Release Note for Marvell B0 CPU

First Published: 2022-06-13

Overview

Figure 1: Label on the Device

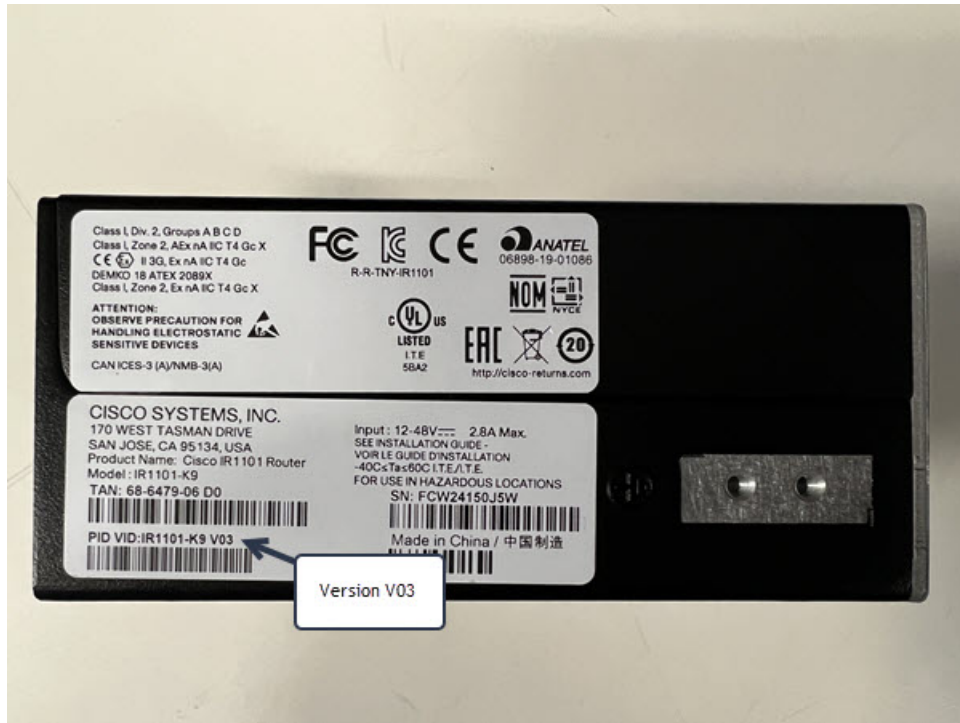
To check for your revision of CPU using the product label, look for the VID which starts with a "V". The following example is from an IR1101:

The V03 label indicates that this product has the B0 CPU. See the [Platform Matrix, on page 4](#) for the VID for each product updated with the B0 revision CPU.
